Product Change Notice

Title of Change: TK-28FE – Product Specification Change

Type of Change: Mechanical Dimensions

Mechanical Outline

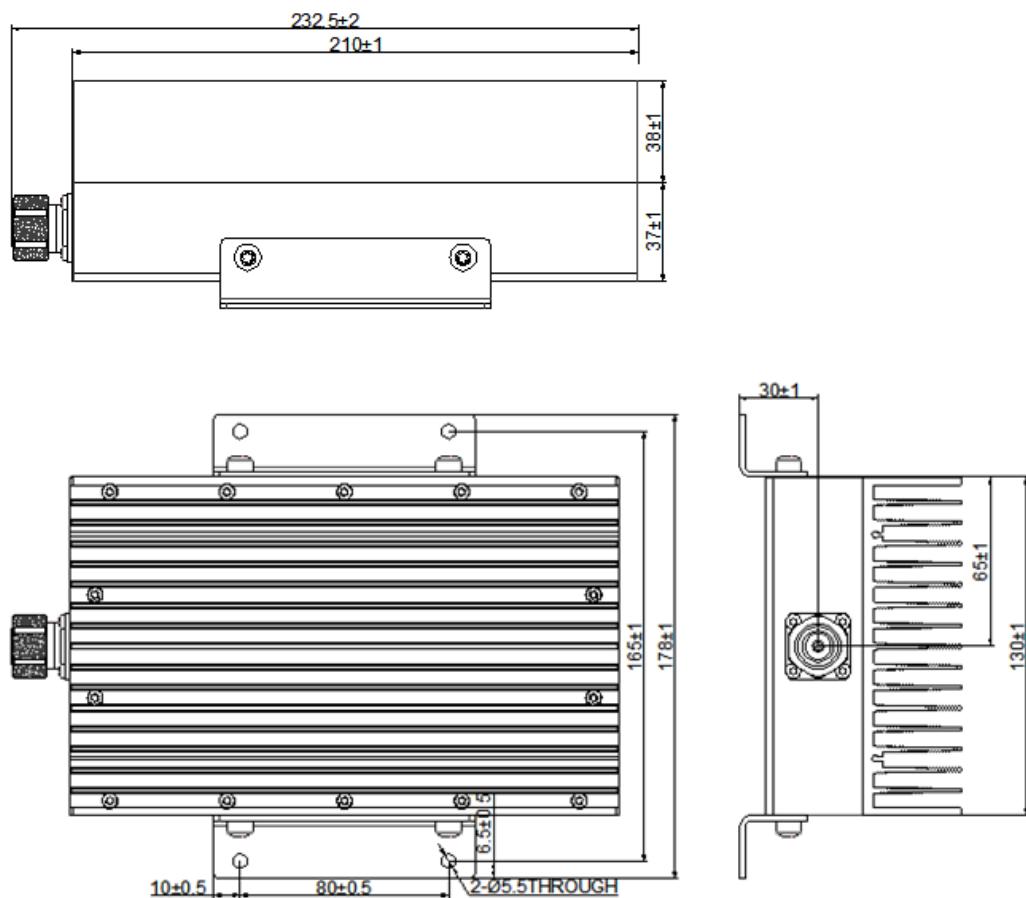
Change Description The TK-28FE Low PIM Termination has been optimized with an updated mechanical design that reduces overall size and weight. These dimensional improvements maintain the existing electrical performance and operating frequency range of 350-2700 MHz while improving form-factor, thermal efficiency, and ease of integration.

Reason for Change: To reduce overall size and weight, improve production, and enhance installation efficiency while maintaining the same electrical performance.
